Planning and Zoning Commission

May 6, 2020 – REGULAR MEETING

SUBJECT: **ITEM P20-035 & P20-036:** DEVELOPMENT PLAN AND HILLSIDE
CONDITIONAL USE PERMIT FOR A LAND DIVISION AT 808 UPPER REDMOND
ROAD IN THE NEIGHBORHOOD LOW DENSITY – 1 (NL-1) ZONE.

DEVELOPMENT PLAN AND HILLSIDE CONDITIONAL USE PERMIT
LOTS 1 & 2

THOMPSON CONDITIONAL USE PERMIT

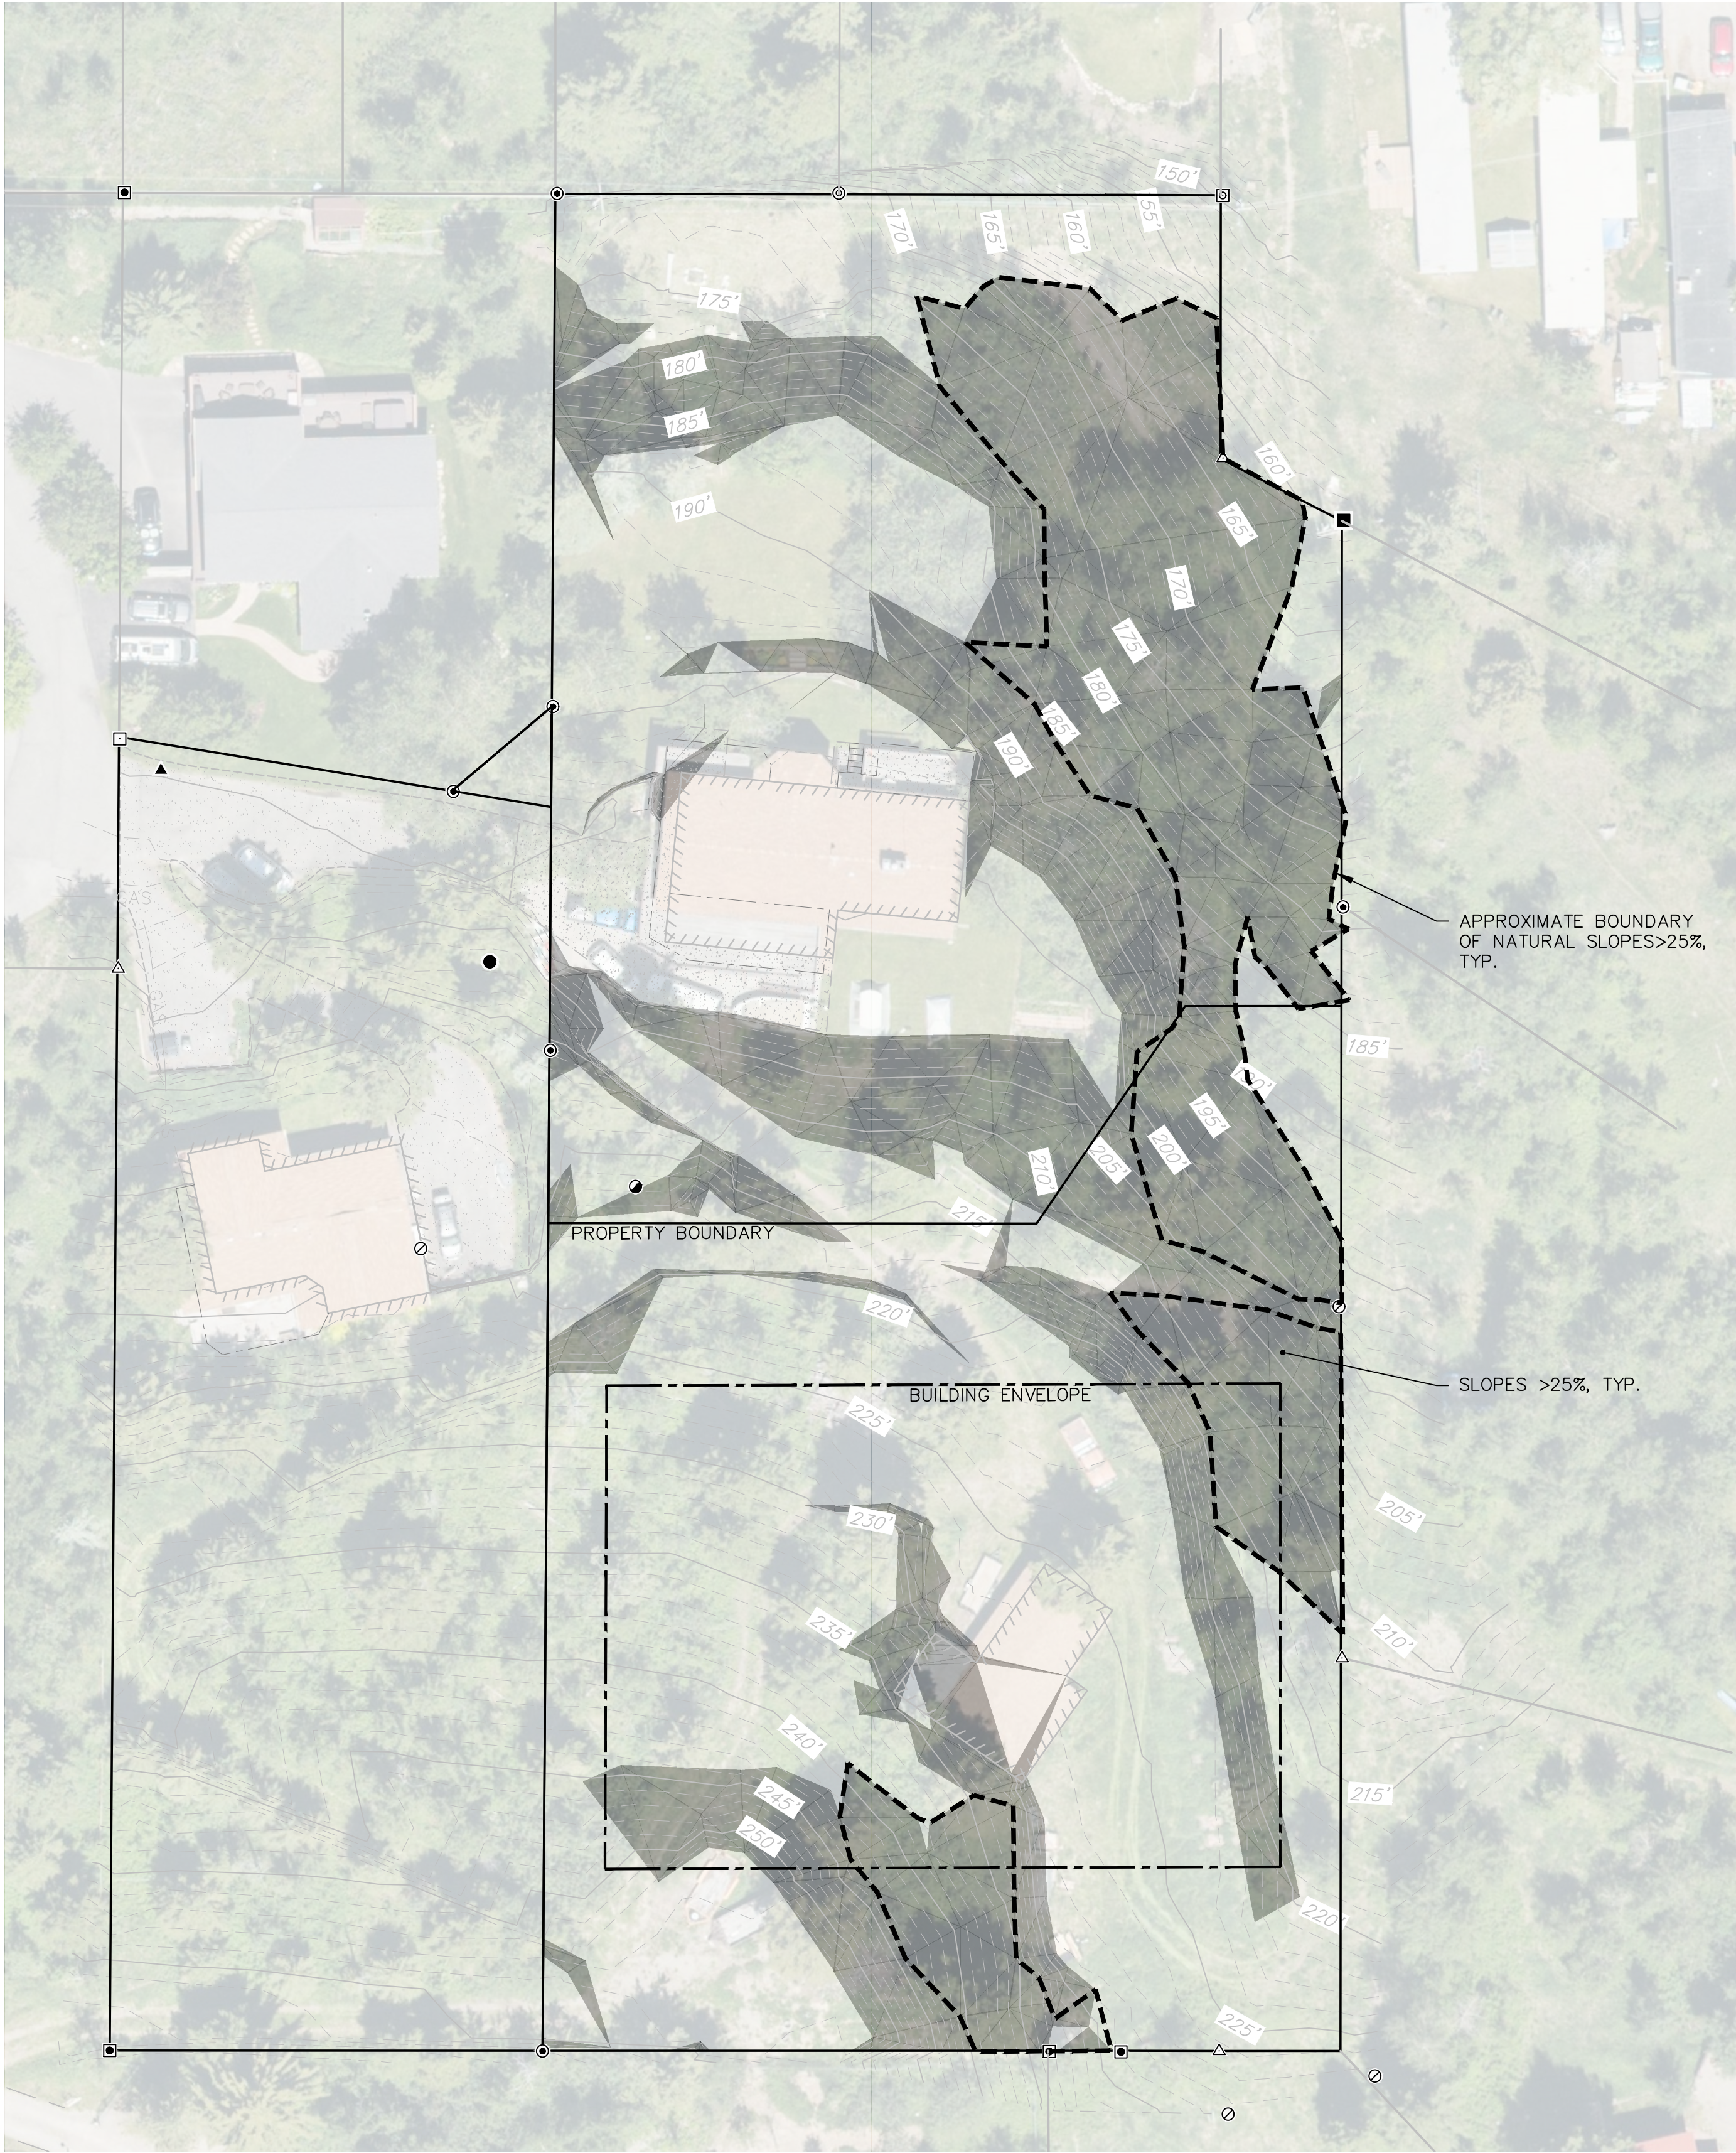
4. Specify the specific methods that were used to determine the stability.
5. Provide the seismic analysis and factor of safety for slope stability.
6. Figure 8: Clarify where Section A is located. Identifying the test pits on Figure 8 would also be helpful for reference.

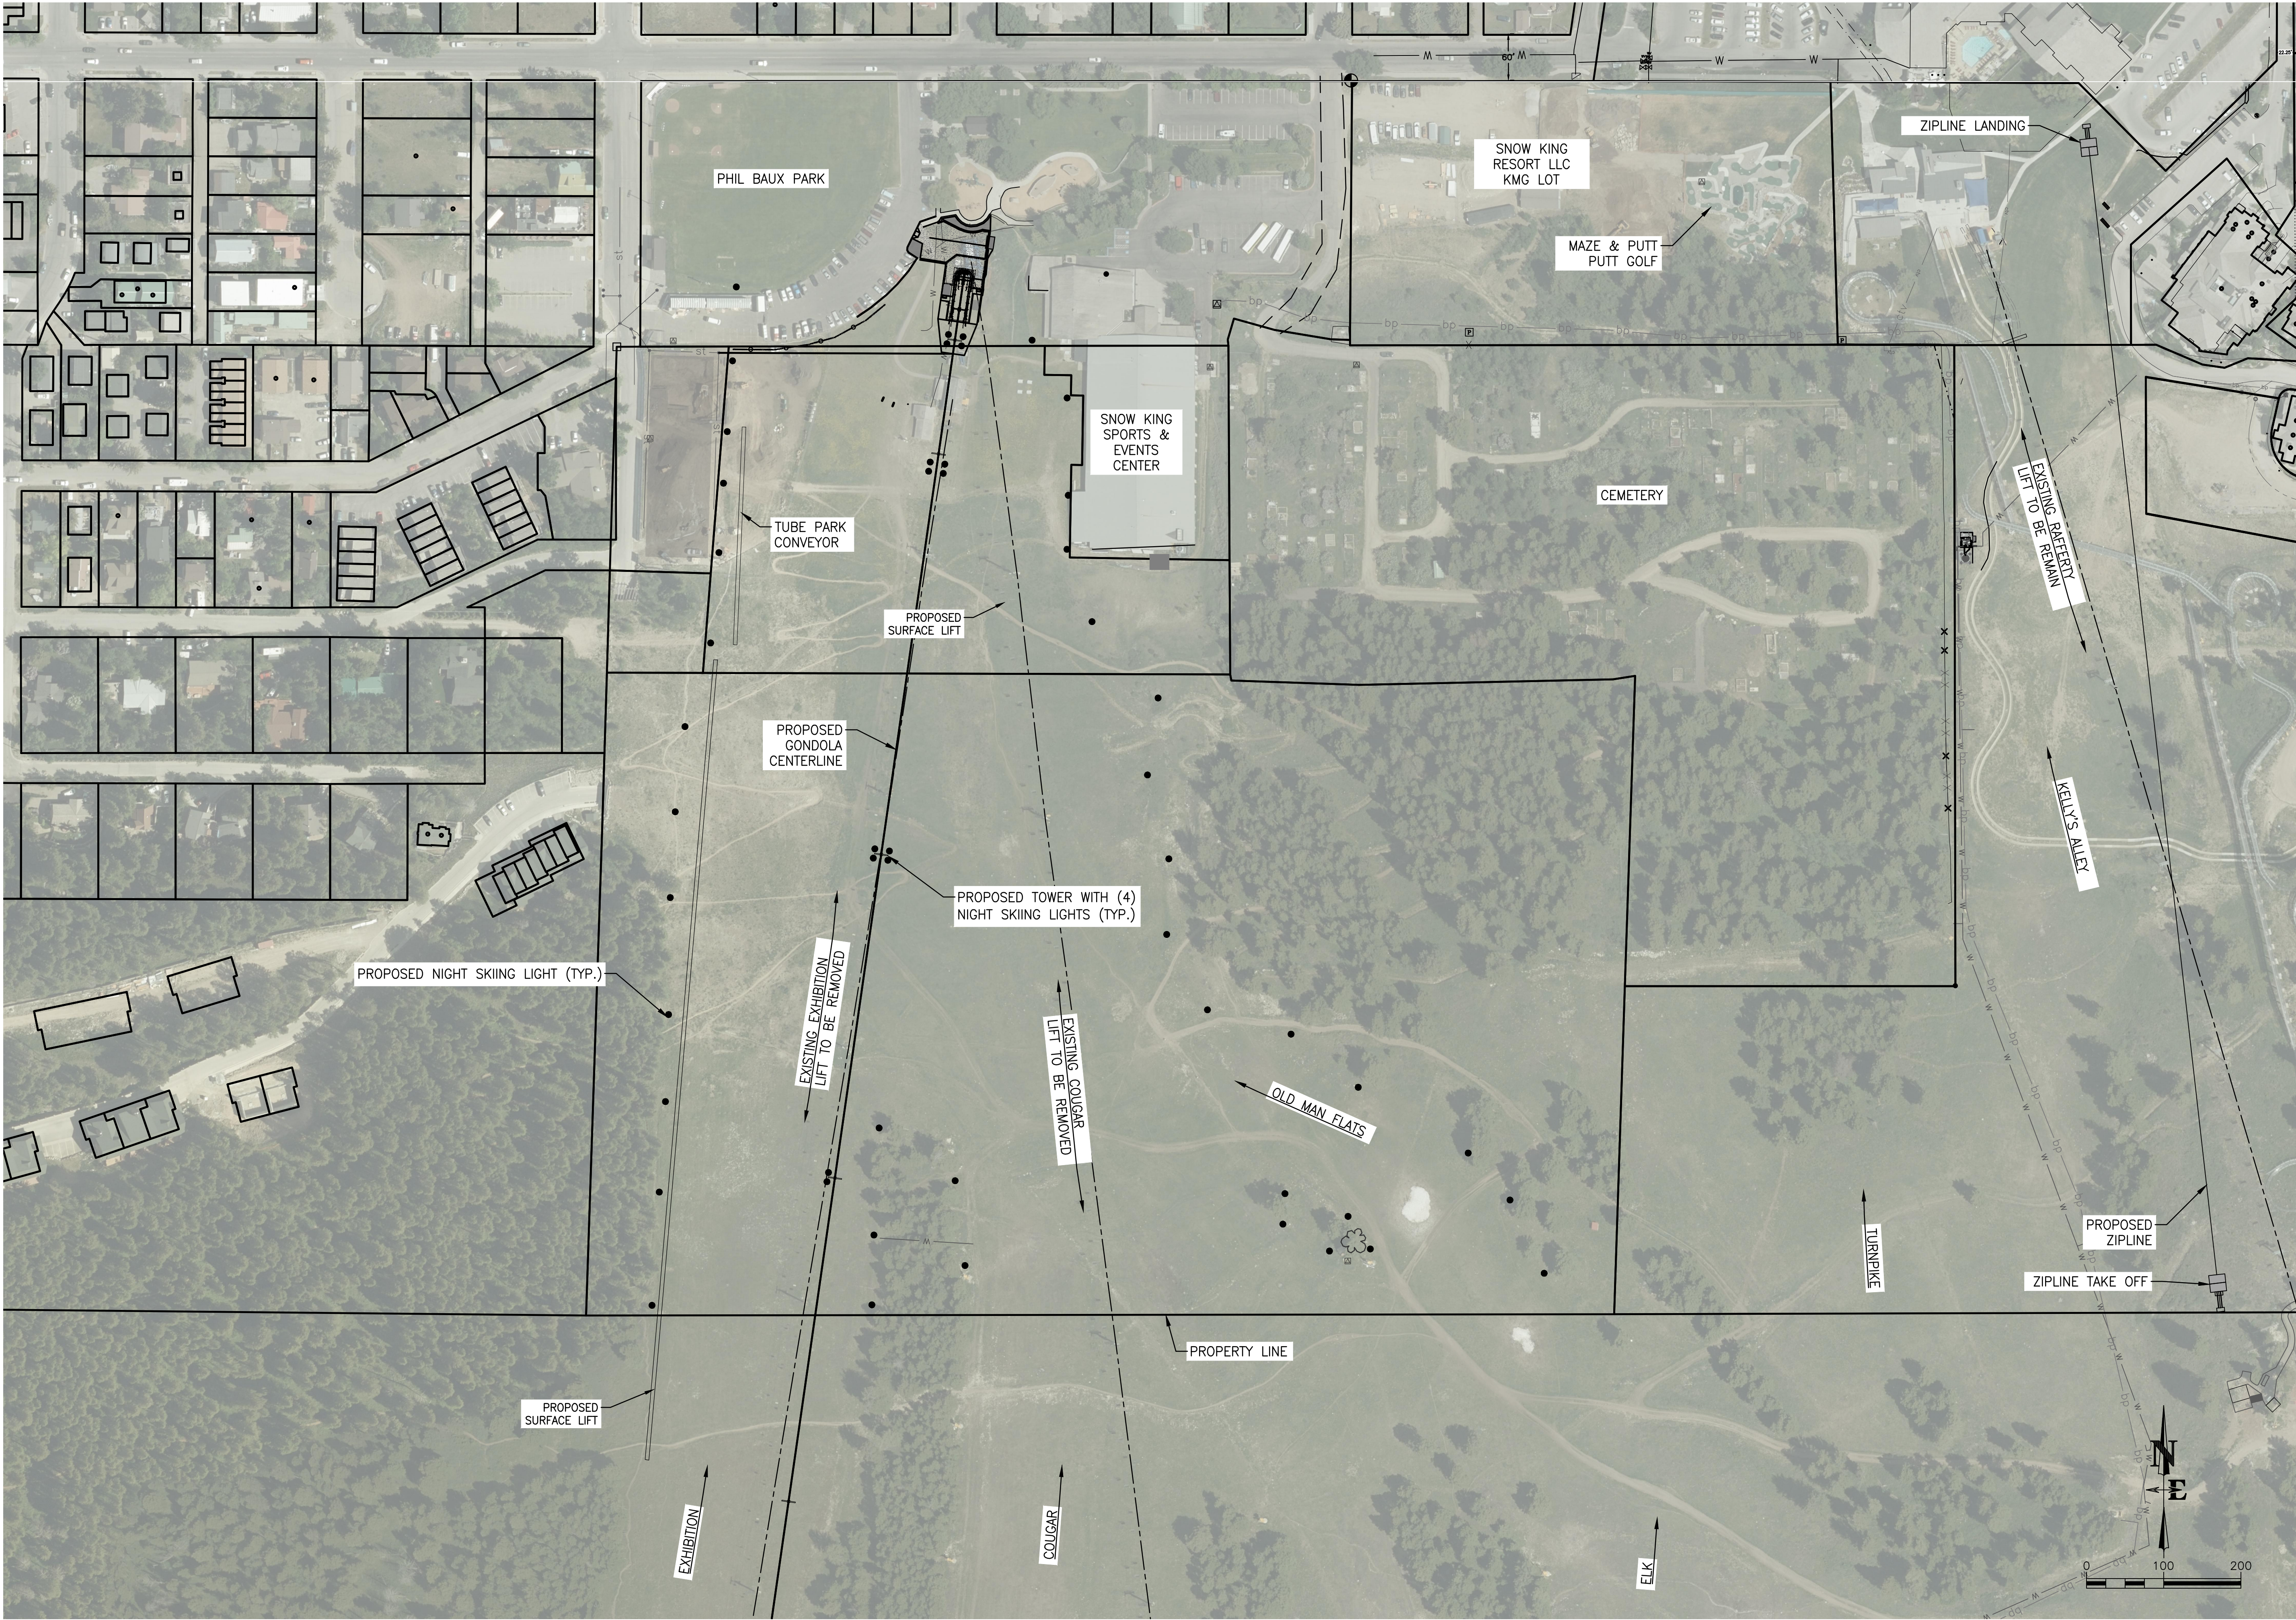
Landscape features for the gondola are identified on sheet C2.0 of the applicant's submittal. These features include a landscape buffer between the playground and sidewalk in Phil Baux Park and the proposed gondola loading plaza. The edge of the landscape buffer also serves as bench seating on both sides. Per the applicant's narrative, the landscaping within the buffer will match the landscaping that currently exists in the park. The final landscape design in the plaza will be determined at the time of Building Permit submittal as the applicant has agreed to reposition the gondola and plaza features in order to better integrate the gondola facility into future improvements to Phil Baux Park. Please see the discussion below regarding proposed improvements to Phil Baux Park.
